Buncombe County Planning Board April 20, 2015

SUB2015-00078: Drew Norwood of Windsor Built Homes, Inc. was seeking preliminary approval of Glen Bridge Road Subdivision, which is located at 925 Glen Bridge Road SE (PIN 9634-63-4032).

Buncombe County Planning Board Meeting Recommended Staff Conditions SUB2015-00078 April 20, 2016 Glenn Bridge Subdivision

Buncombe County Planning Board Meeting Recommended Staff Conditions **SUB2015-00079** April 20, 2016 **The Ramble Block E**

sheet <u>C-100</u>

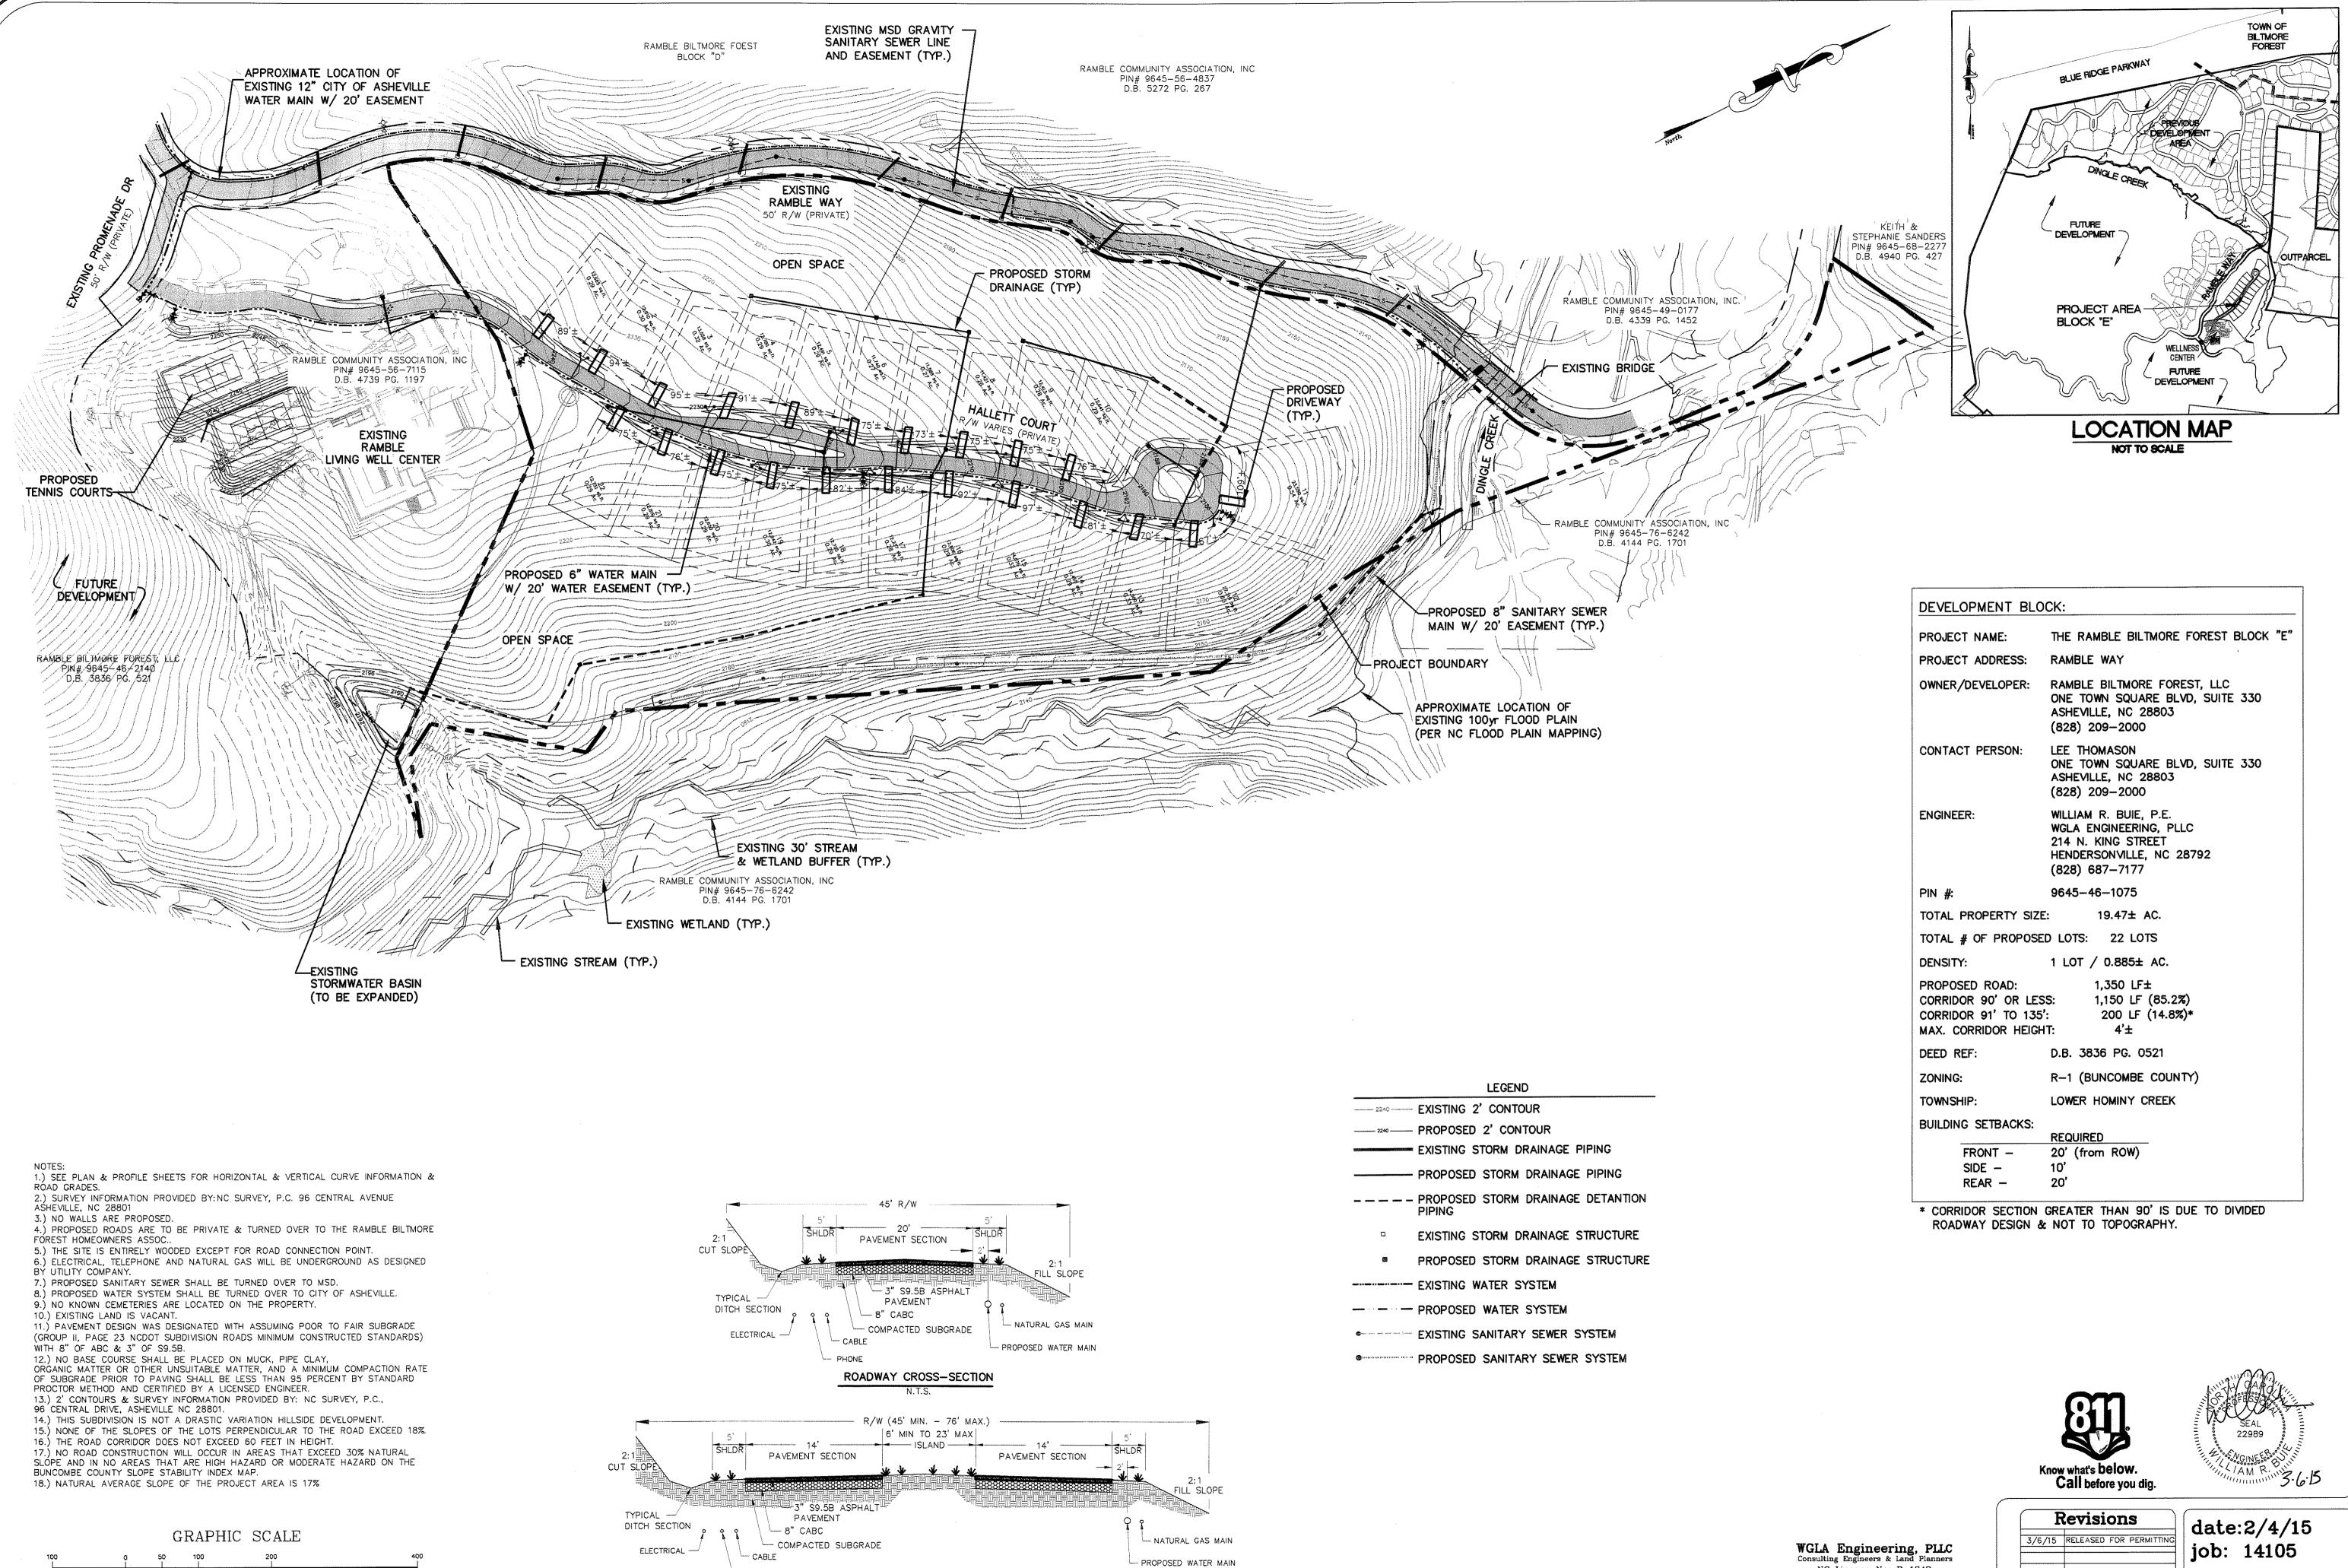
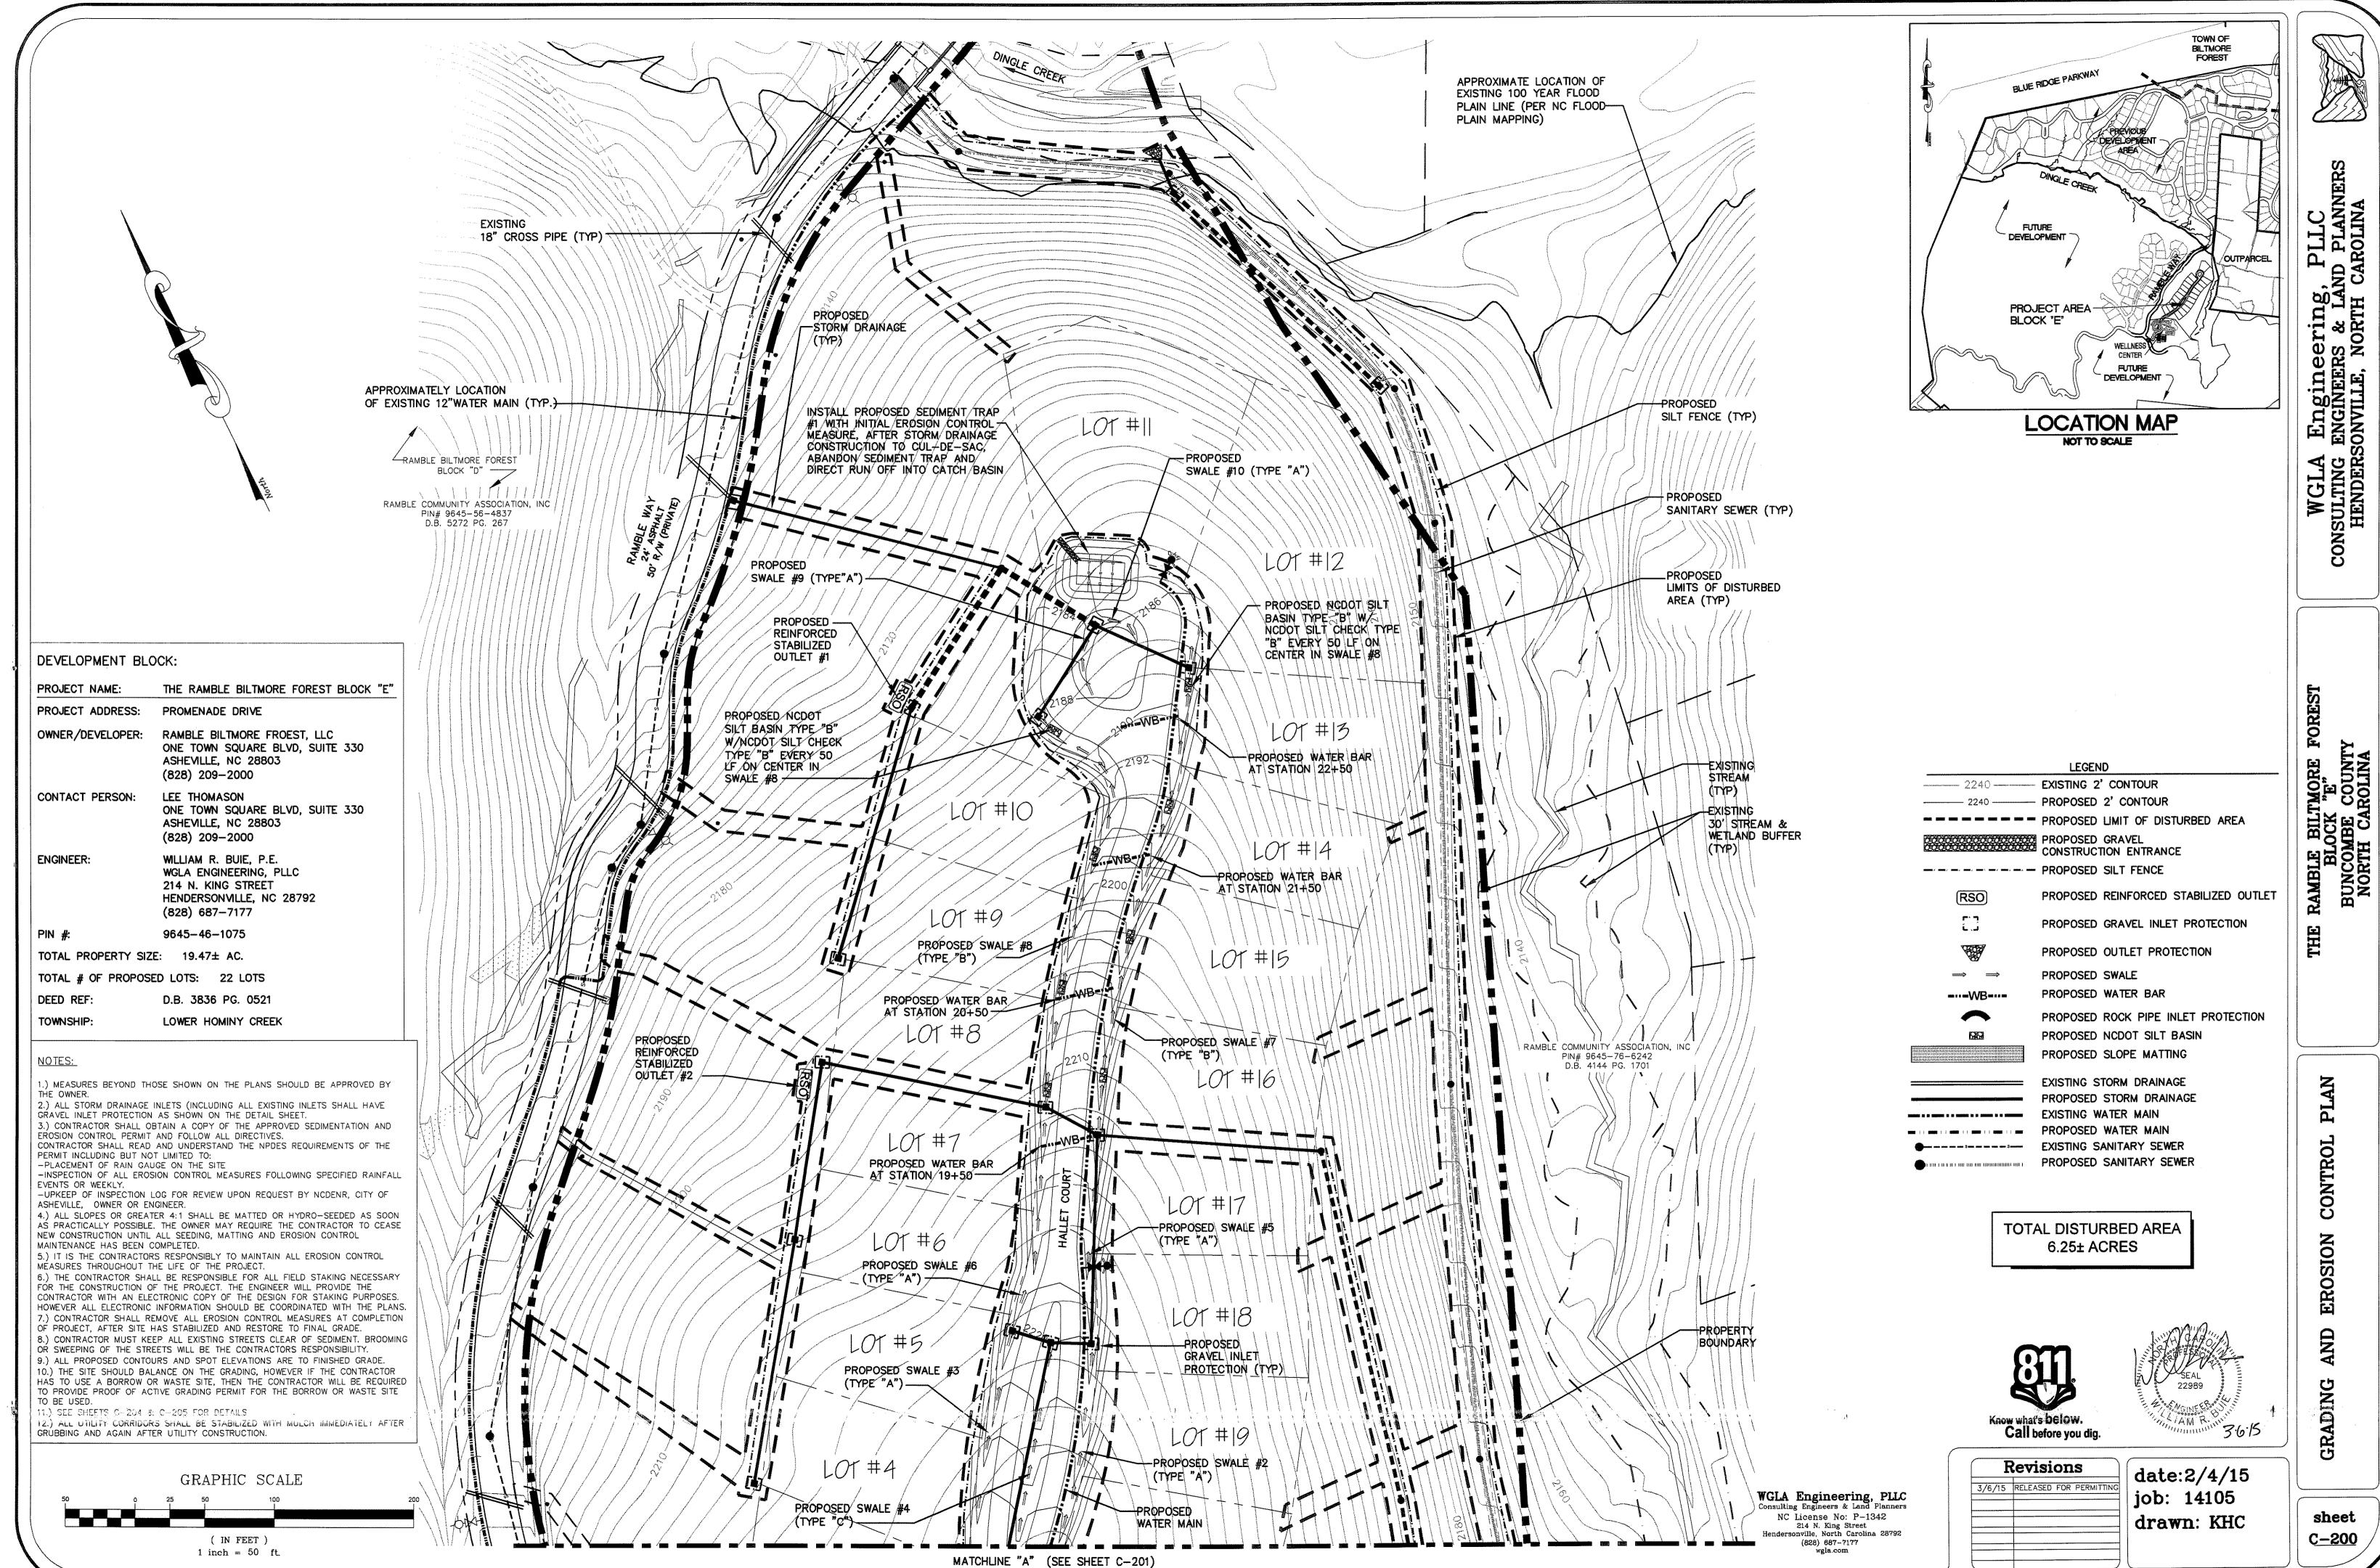
GRANTED PRELIMINARY APPROVAL WITH CONDITIONS AT THE 4/20/2015 PLANNING BOARD MEETING

1. Provide proof of approval of road names and addresses from E-911 Addressing.

2. Provide proof of approval from the Buncombe County Erosion Control Officer that an Erosion Control Plan has been submitted and approved for the project. No grading shall occur on the site until an approved Buncombe County Erosion Control

3. Provide proof of approval from the Buncombe County Stormwater Administrator that a stormwater management plan has been submitted and approved for the project. No grading shall occur on the site until an approved Buncombe County

4. Provide proof of approval of system design for City of Asheville Water lines. Proof of acceptance of the water lines into the City of Asheville's water system or an engineer's certification that the system has been installed to City of Asheville's standards will be required prior to recordation of a final plat or release of a financial guarantee.

5. Provide proof of approval of system design from the Metropolitan Sewerage District. Proof of acceptance of the sewer lines into the Metropolitan Sewerage District sewage system or an engineer's certification indicating that the system has been installed to MSD standards will be required prior to recordation of a final plat or release of a financial guarantee.
